E C O L O G I C A L R E V I E W

West Lake Boudreaux Shoreline Protection and Marsh Creation

State No. TE-46

November 8, 2005

Figure 1. West Lake Boudreaux Shoreline Protection and Marsh Creation project plan map.

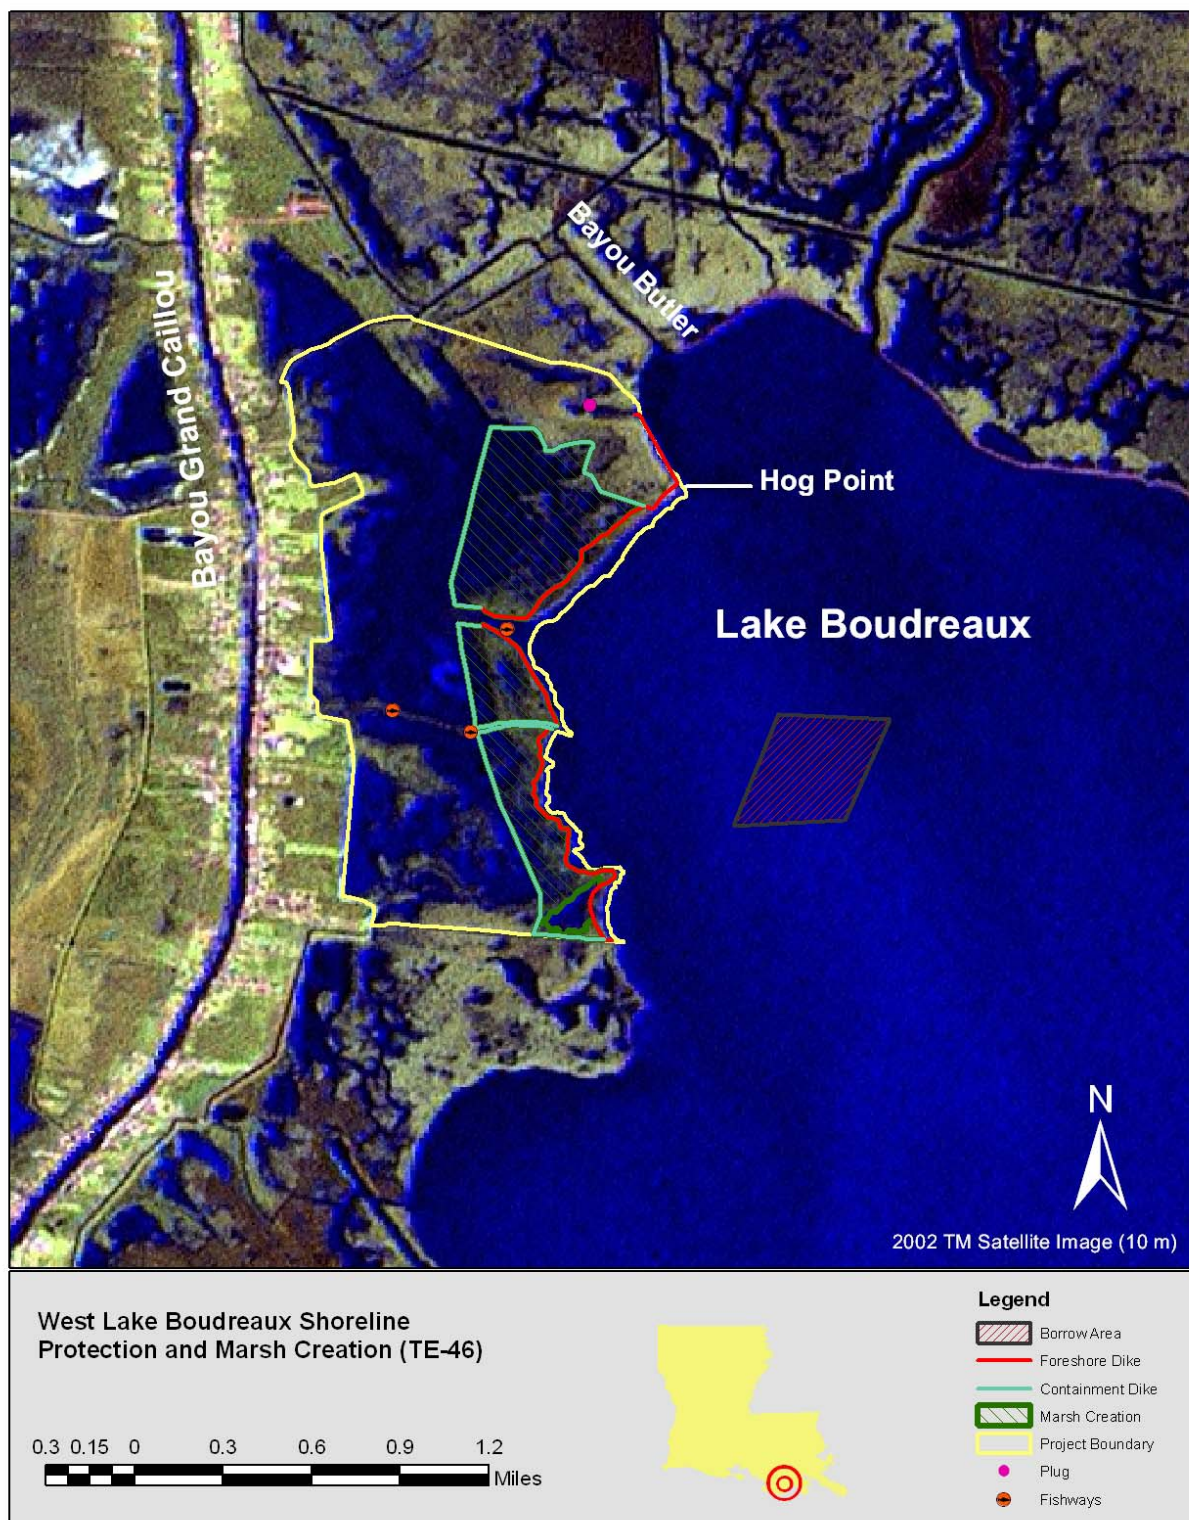
- The expectation is that the earthen containment dike will erode to marsh elevation, thereby eliminating the need for it to be manually breached. However, if this phenomenon does not occur naturally within the first 2 to 4 years of the project life, breaks should be made so that the created marsh does not become impounded. This will promote a more natural hydrologic flow within the project area, thereby allowing movement of nekton to and from the marsh, and allowing for sediment and nutrient transport (Shafer and Streever 2000).

Figure 2. Rock dike settlement curves overlay (data from Burns Cooley Dennis, Inc. 2003).

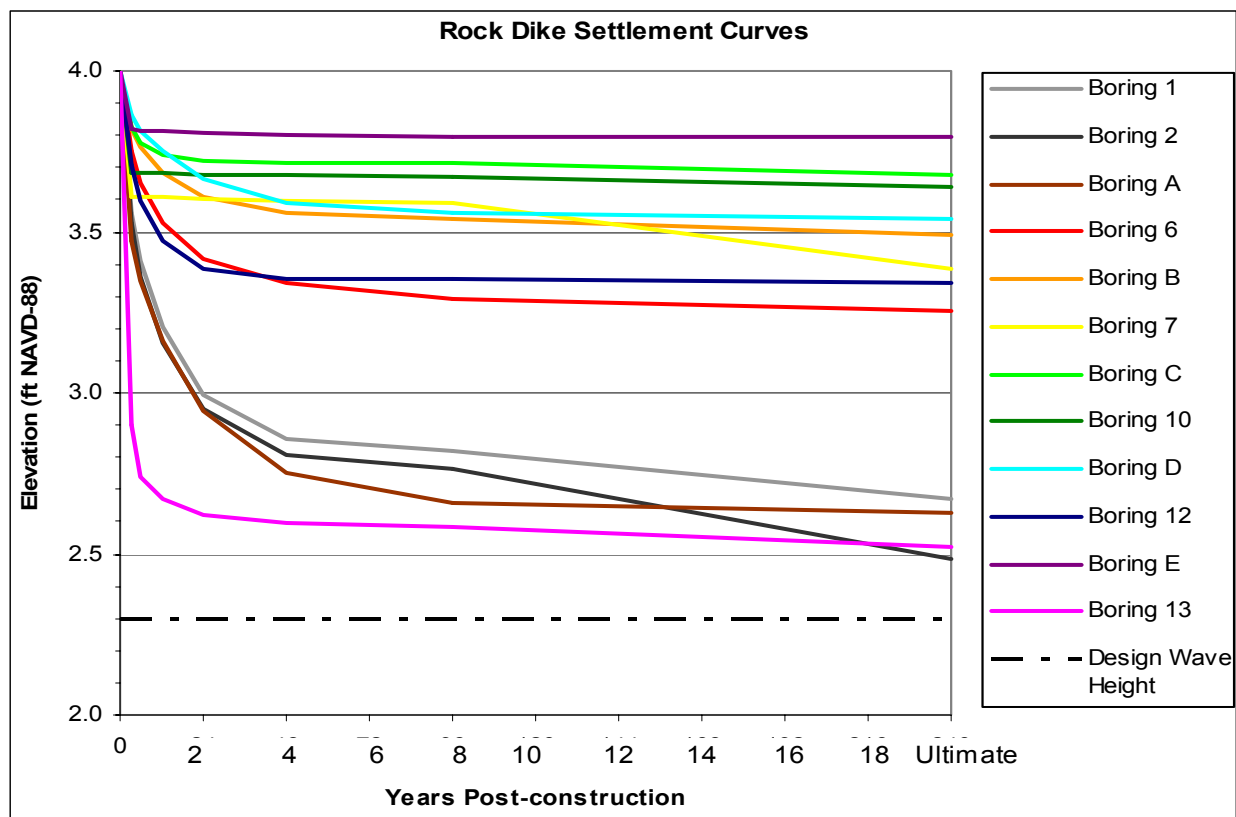
Separate settlement curves were provided in the geotechnical report for individual boring locations based on a rock dike height of +4.0 feet NAVD 88 (Burns Cooley Dennis, Inc. 2003). An aggregated overlay of each of these individual curves is shown in Figure 2 below. A review of the settlement predictions by the project team engineers determined that a dike elevation of +3.5 feet NAVD 88 would provide adequate protection for the design wave height. It should be noted that the settlement predictions do not account for subsidence.

- The geotechnical report evaluated the settlement of the foreshore rock dike constructed to an elevation of +4.0 feet NAVD 88 (Figure 2). Based on the estimates of settlement for 12 individual soil borings, it was determined by project team members that the rock dike could be constructed to an elevation of +3.5 feet NAVD 88 and still provide the desired level of protection for the 20-year project life. Although this seems logical, the analysis fails to take into consideration local subsidence that has been estimated to be 0.43 inches per year (1.09 centimeters per year) or 0.7 feet over 20 years (Penland and Ramsey 1990). Therefore,

maintenance and monitoring efforts should be coordinated to ensure structural stability and functionality over the 20-year project life. It is important to note that subsidence was not accounted for in the design of the rock dike; however, subsidence was acknowledged and accounted for in the marsh creation component of this project.
